RE: Willow Pass Generating Station
Application for Certification 08-AFC-6

Responses to CEC Data Requests (#58-61, 70, and 72)

Application for Certification (08-AFC-6) for **WILLOW PASS GENERATING STATION** Pittsburg, California

FIGURE 61-1b

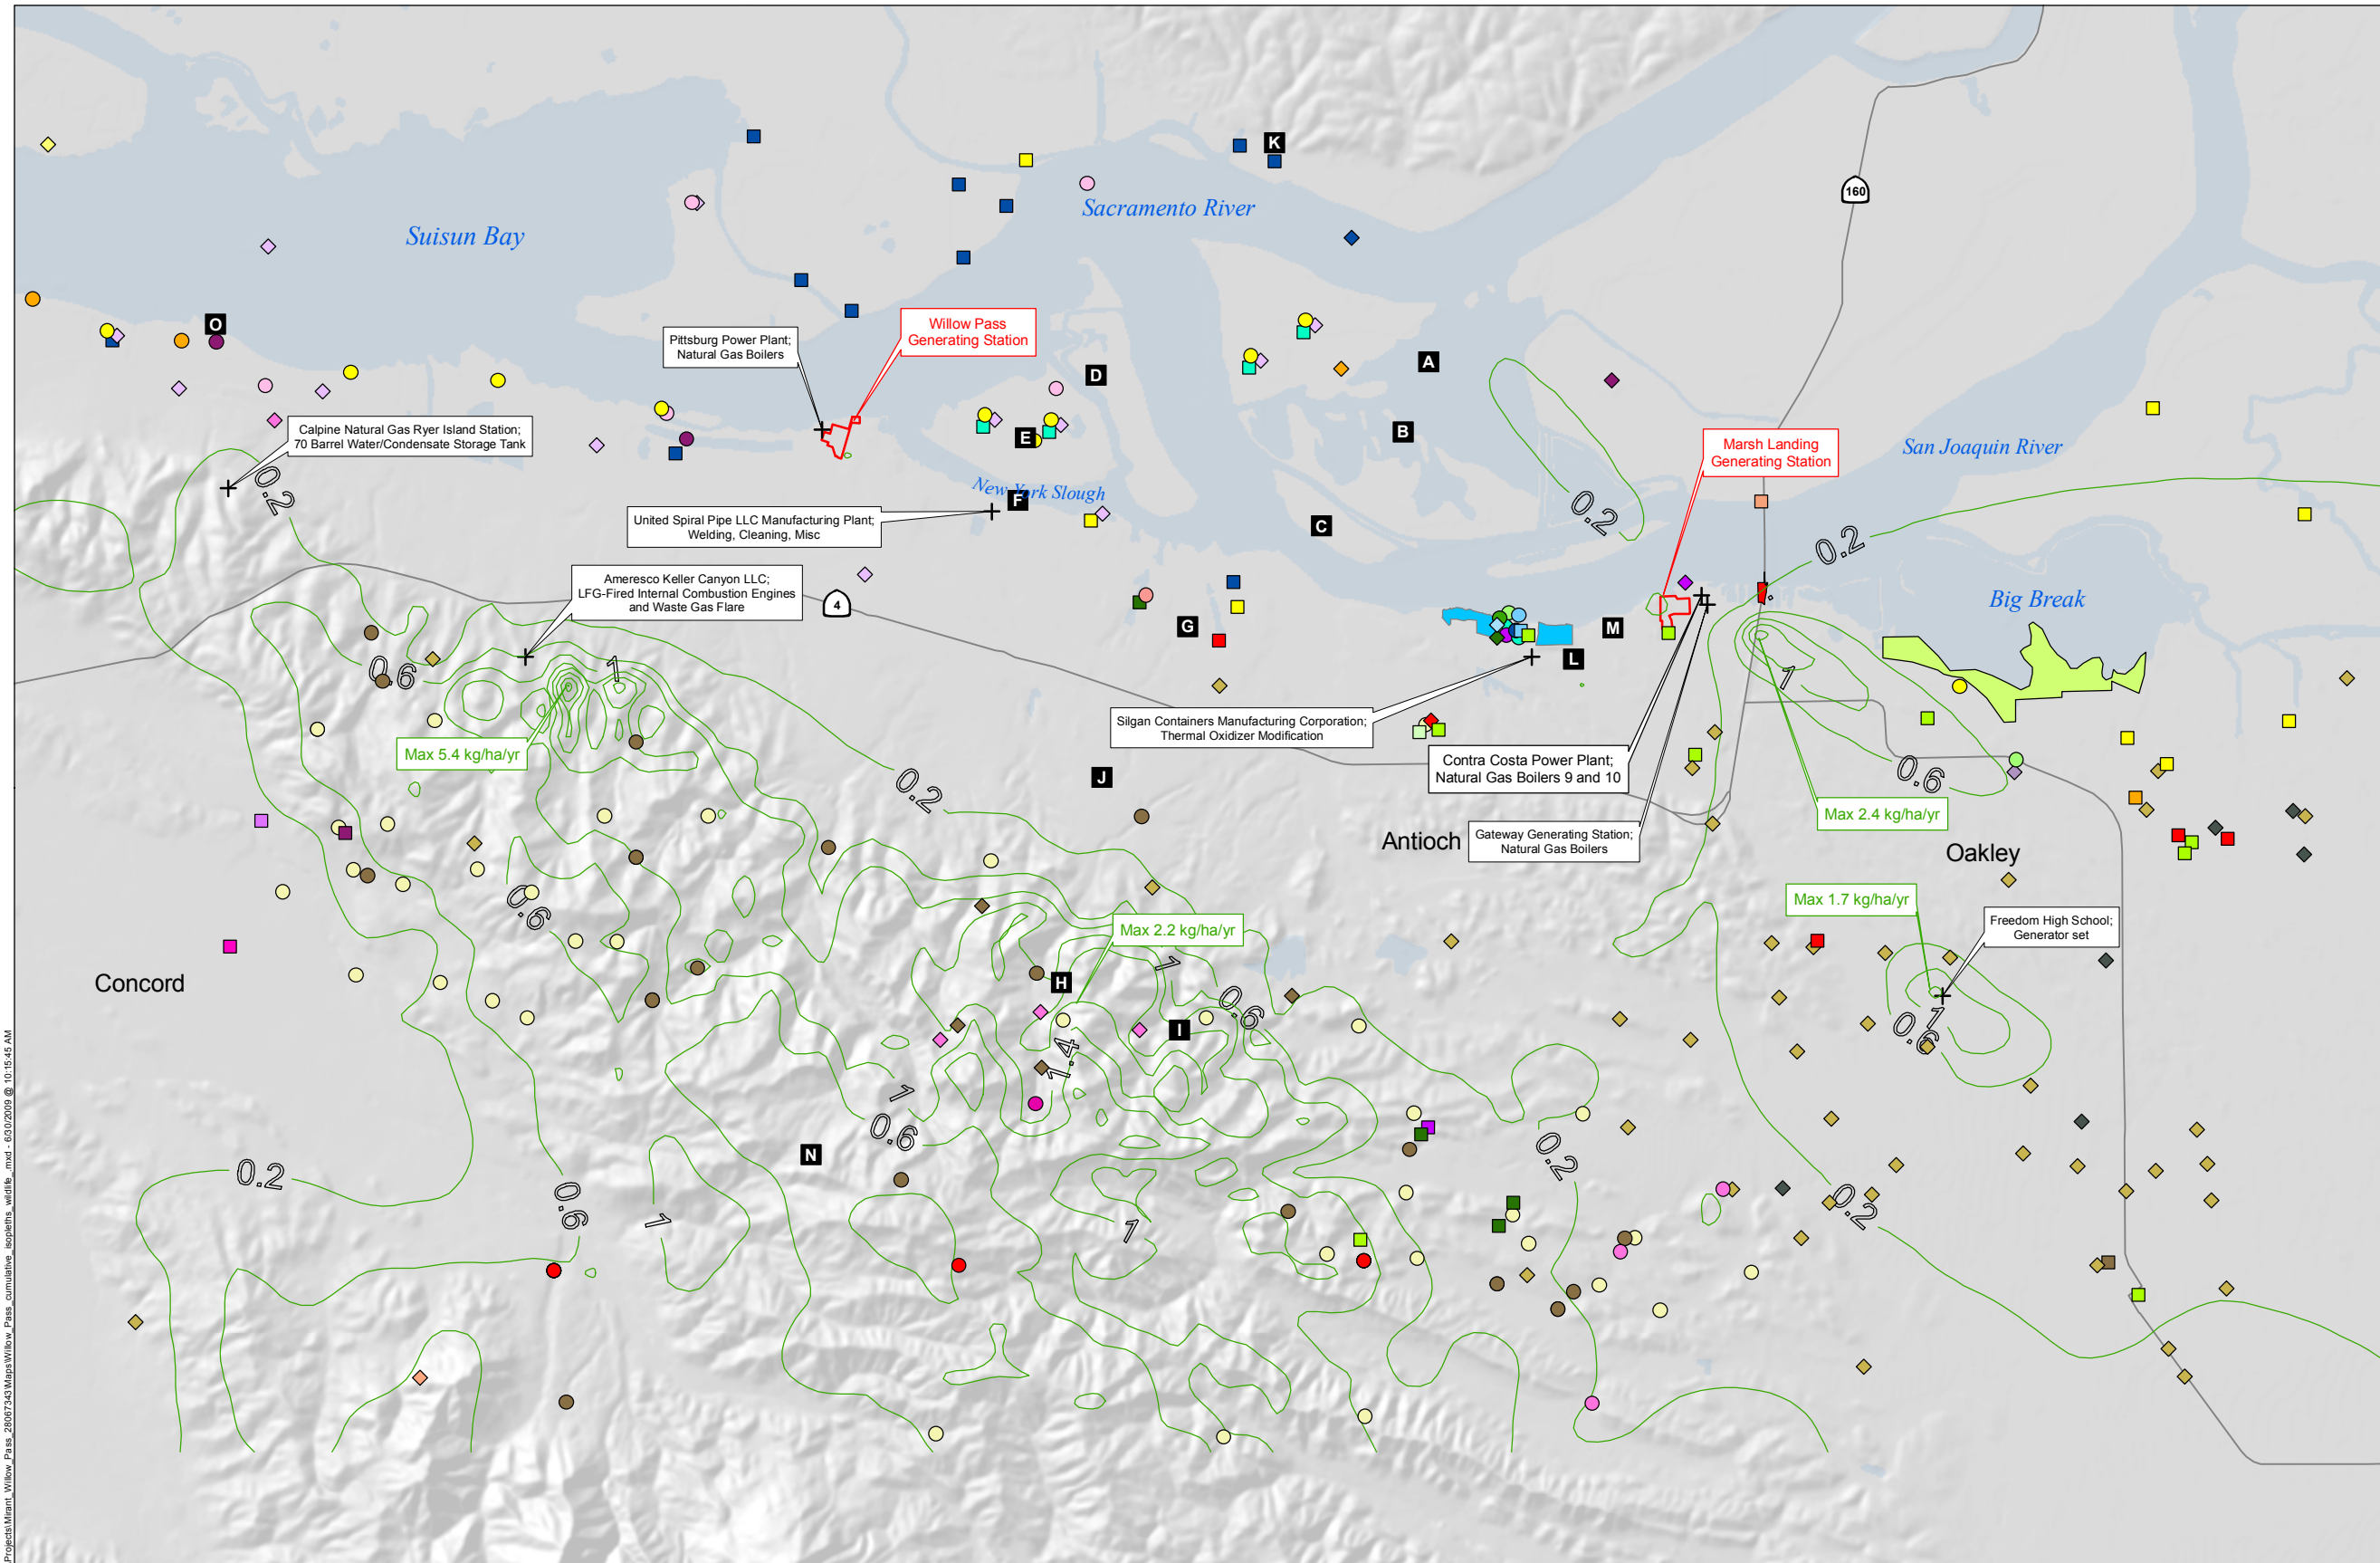
61. Please update the cumulative impact analysis (Tables 57-1 and 57-2) in Responses to Data Request Addendum Set #1A – Data Request #57 with nitrogen deposition values in kg/ha/yr. Provide an isopleth graphic over USGS 7.5-minute maps (or equally detailed map) of the direct nitrogen deposition values in the cumulative analysis.

Figures 61-1a and 61-1b provide the isopleths for nitrogen deposition rates in kg/ha/yr due to all cumulative sources listed in Table 61-1. Figure 61-1a shows the federal and state listed special-status vegetation species. Figure 61-1b shows the federal and state listed special-status wildlife species.

As seen in Figures 61-1a and 61-1b, the maximum cumulative nitrogen deposition value occurs in the hills south of Pittsburg, which is located approximately 3 miles southwest of the WPGS project site. The maximum nitrogen deposition rate for all cumulative sources is estimated to be 5.4 kg/ha/yr (without background) near the Ameresco Keller Canyon facility. This is the only area that would exceed the benchmark of 5 kg/ha/yr with background; however this area is not considered sensitive to nitrogen deposition since sands or serpentine soils are not known to be present. Approximately 98 percent of the highest nitrogen deposition rates in these hills are caused by nitrous oxide emissions from sources at the Ameresco Keller Canyon LLC facility, which includes two landfill gas-fired internal combustion engines and a waste gas flare.
